CERTIFICATE OF THE SECRETARY OF ENERGY AND ENVIRONMENTAL AFFAIRS
ON THE
ENVIRONMENTAL NOTIFICATION FORM

PROJECT NAME : Municipal Solid Waste Transfer Center and Recycling Center
Operations Expansion
PROJECT MUNICIPALITY : Dedham
PROJECT WATERSHED : Neponset River
EEA NUMBER : 15635
PROJECT PROPONENT : Dedham Department of Public Works
DATE NOTICED IN MONITOR : January 25, 2017

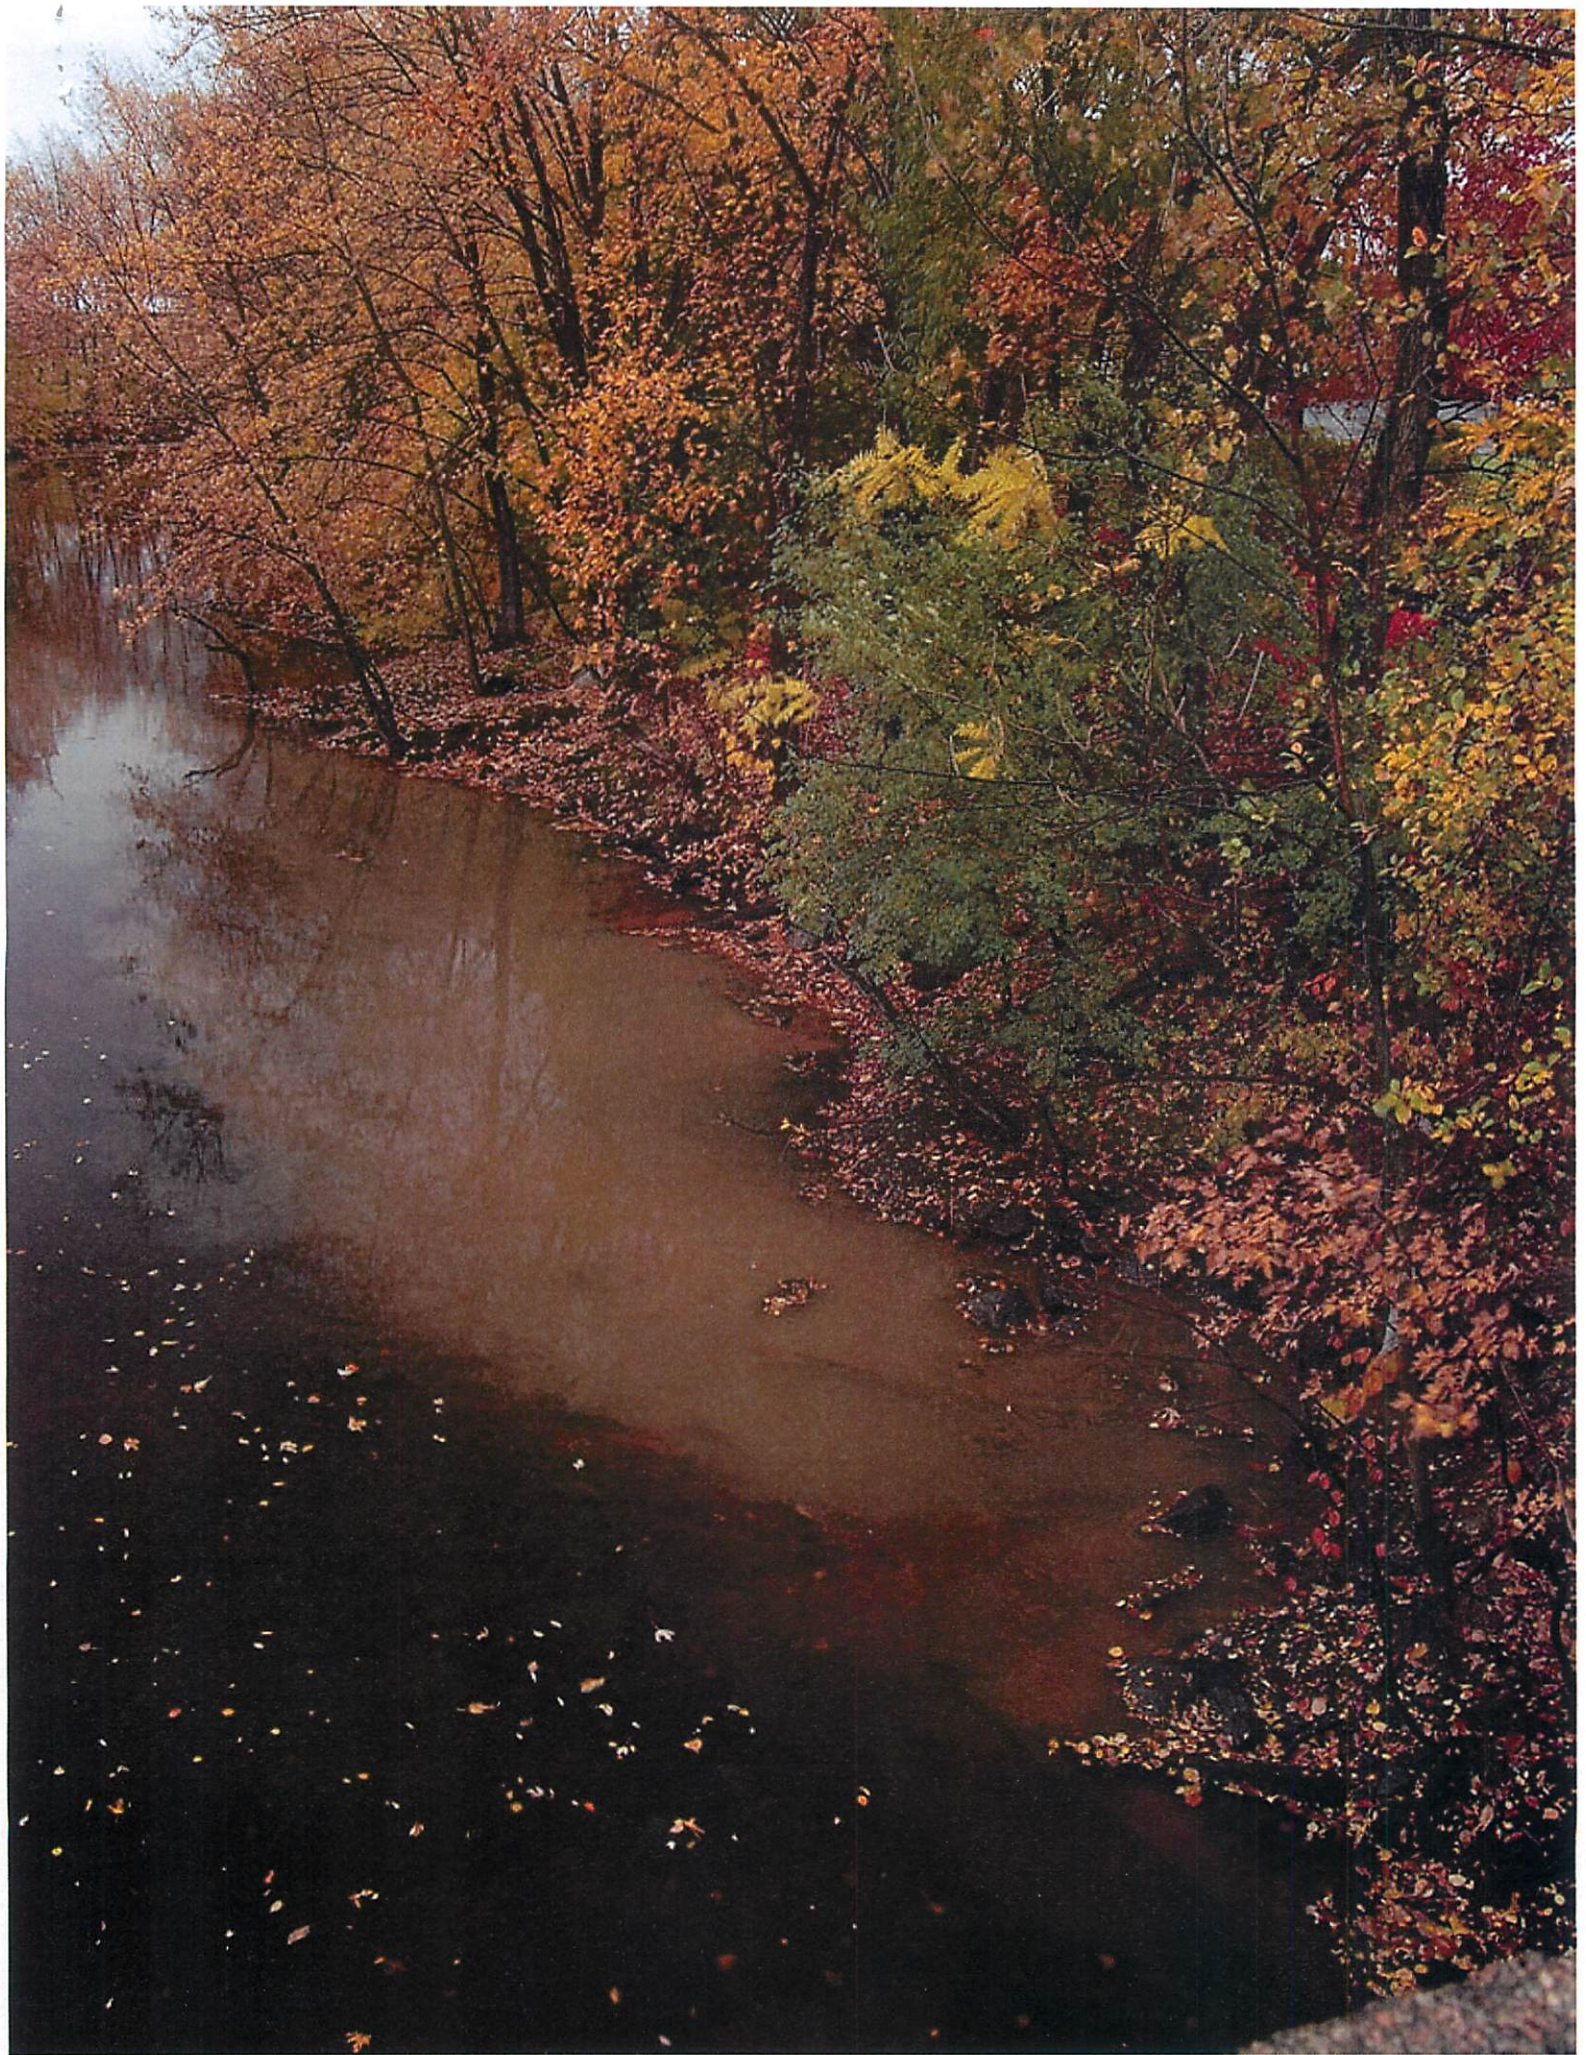
This aerial shows non-precipitation drainage from containers going to the Mother Brook.

Attachment C - Snow Pile

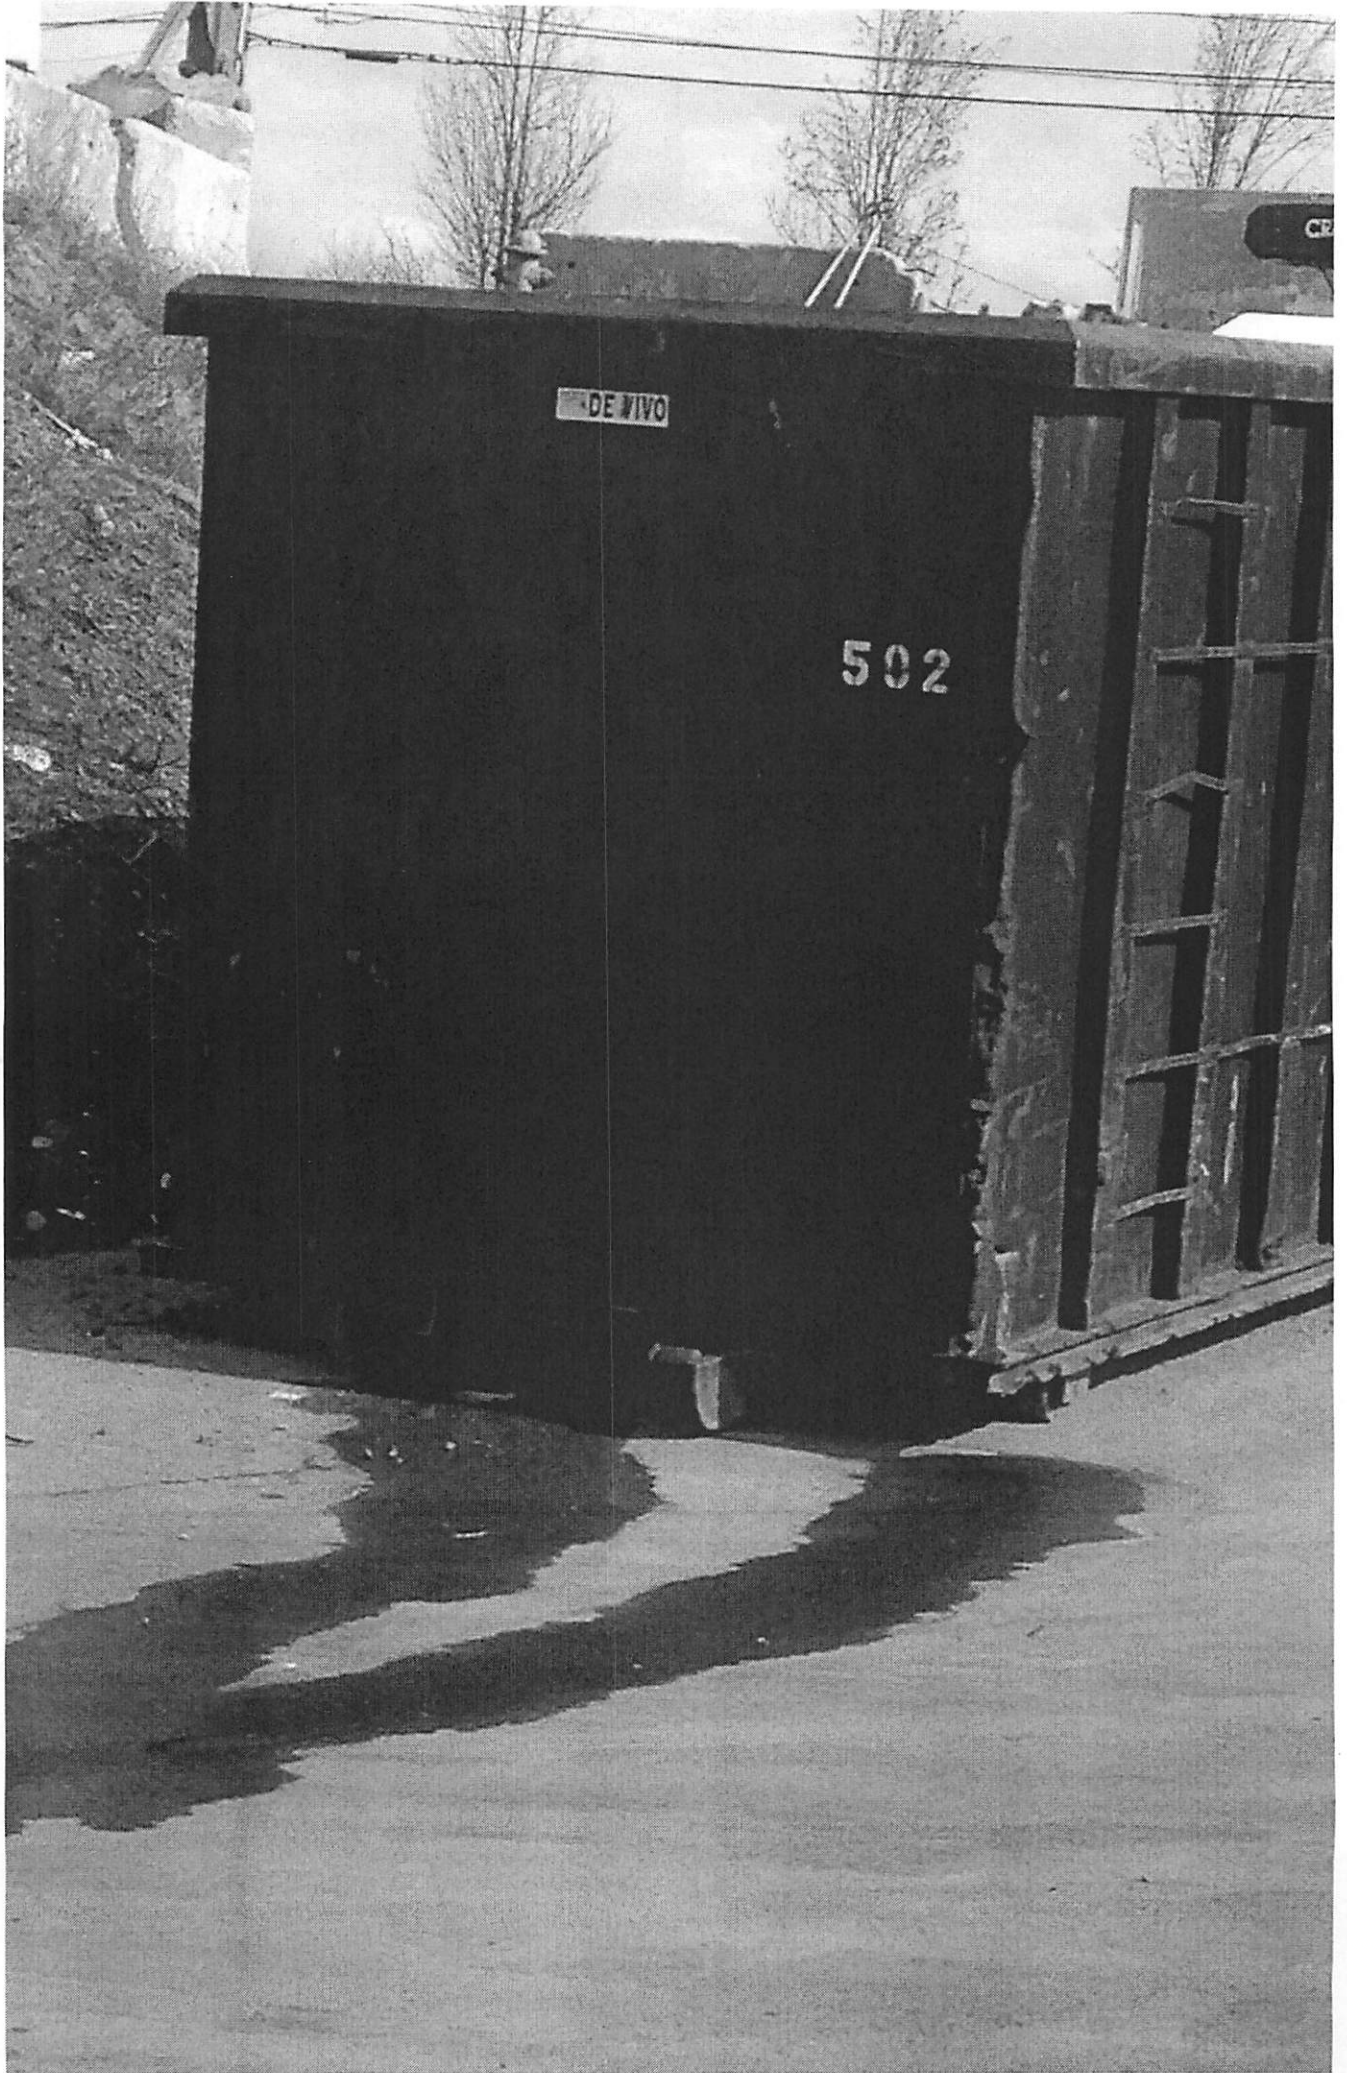
Stormwater Management on the Site is a problem for the Mother Brook. The ENF indicates that there will be a slight increase in impervious area on the Site. A new stormwater management system is proposed to meet the standards in the MassDEP “Massachusetts Stormwater Handbook. The potential proprietary treatment system would provide significant improvements in Total Suspended Solids (“TSS”), metal, and phosphorous removal. The “treatment technology features rechargeable, self-cleaning, media filled cartridges.” These improvement sound like a good start to protect the waters of the Mother Brook. However, improved TSS removal translates into increased maintenance. The more solids you take out of the water means that there is more to take out of the system for it to work properly. Care for the water body and maintenance seem to be a big issue for the Site operators. The description “self-cleaning” is a bit deceptive and should raise a red flag. The hoods of the system are “self-cleaning”, but not the media-filled cartridges as the ENF appears to indicate. The media-filled cartridges would need to be periodically replaced, which is a maintenance issue.

Nothing in the ENF addresses the issue of bacteria from the Site entering the waterbody and flowing to the communities downstream. The consultant explained that waste deliveries would be made indoors in the new facility. Indoor waste delivery is a positive improvement to contain odors, noise, and to reduce waste contact with stormwater. However, when asked about the waste storage containers, which add their own bacteria laced effluent to the water, the consultant stated that they would still be needed, but they would not leak. Past practices and evidence shows otherwise. A stormwater system with a recharge area may be the best passive treatment for bacteria.
